# BCAC MOE list of changes to consider PC

Teleconference 5-29-2018 from 10 to noon Eastern.

Teleconference 6-5-2018 from 10 to 10:45 am Eastern.

Figure 2

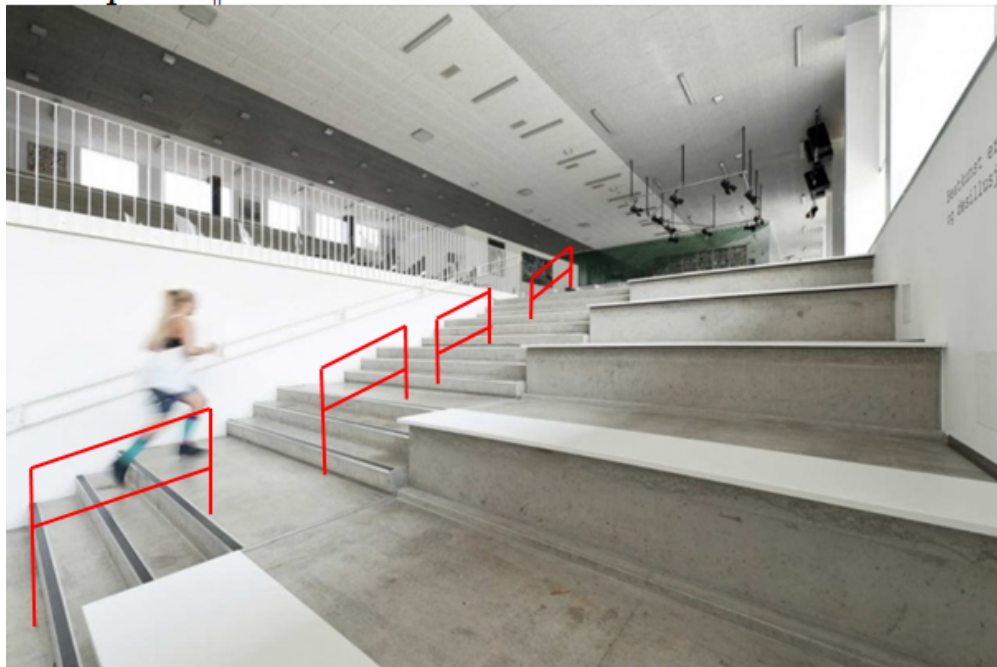
As you can see in the examples provided: Example 1 has two handrails, but with one on the far side of the platform. Example 4 a 2<sup>nd</sup> handrail blocks access to the platforms, so people either climb up the platforms, or go under the handrail. In example 2 and 3 a handrail is only provided on one side of the stairway, regardless of width. None of these configuration would address stairway safety and access to the platforms. Example 3 has an example handrail drawn in red of what these requirements would add.

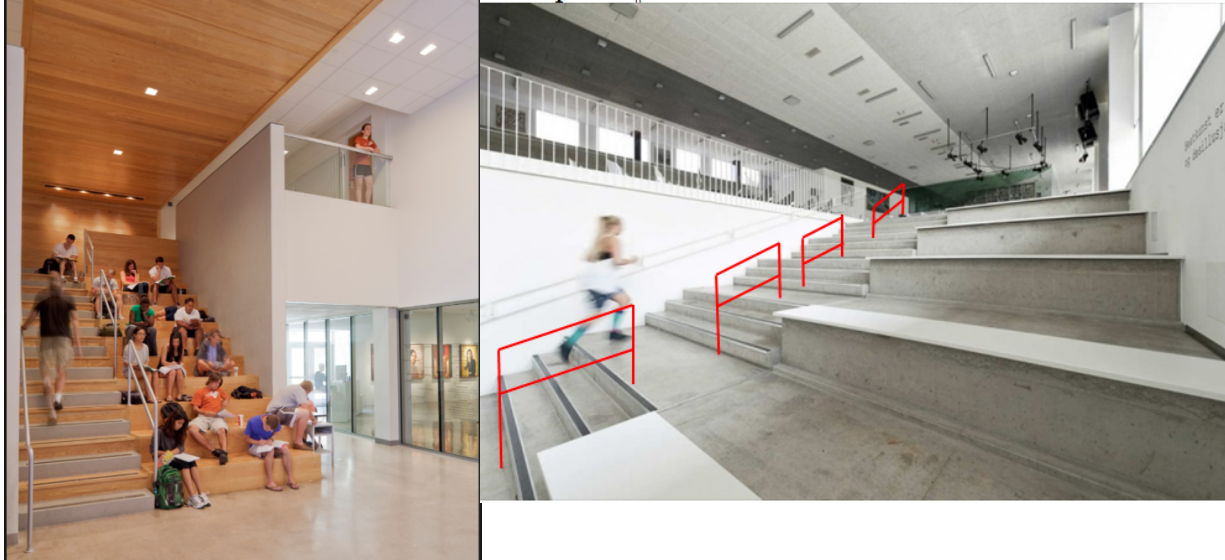
To address the committee's concerns:

The new text in Section 1029.16 and 1029.16.1 will allow for the mid aisle handrail to be the same as for stepped aisles. The 74" was chosen as the point where a 2<sup>nd</sup> handrail in the width of the stepped aisle would still allow for movement up and down on each side of the handrail. The "end of the aisle accessways" was chosen because the tiered platforms do not always contain seats to measure from. Since the seating areas at stepped aisles are tiered platforms (with or without seats), this may be clearer.

Below are three examples with continuous handrails adjacent to seating.

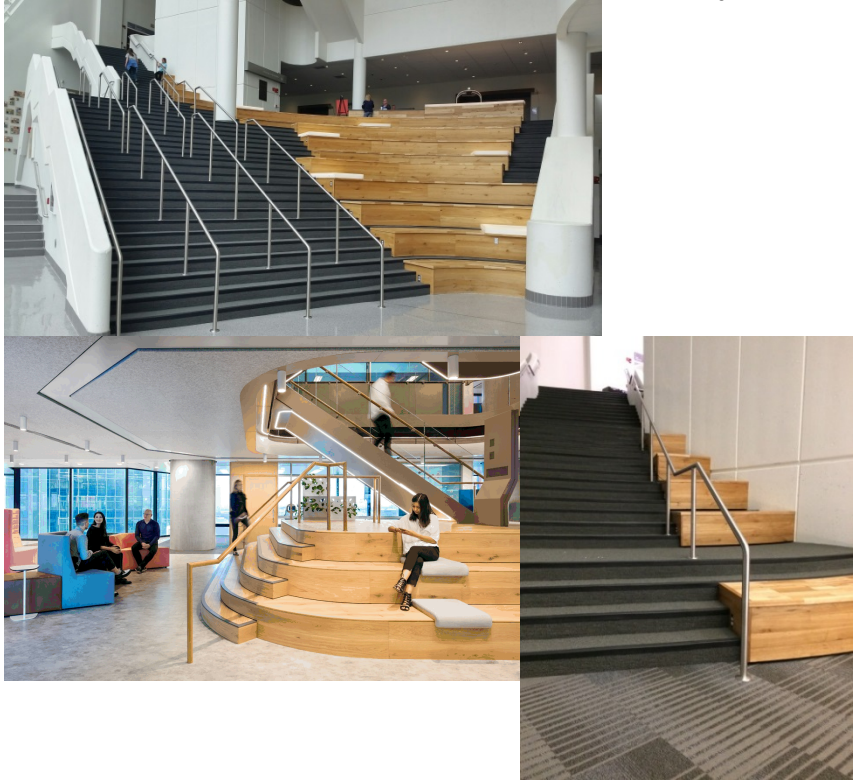
Notes 5-29-2018: Work group was happy with fixes to address committee wording issues. Discuss if continuous should be an option as well for mid-aisle handrail. This is not for a stairway where the handrail is to stop people from moving into an adjacent area. This is the 2<sup>nd</sup> handrail on a stepped aisle where people will be moving into adjacent seating. Is a continuous handrail next to the seating a hazard?
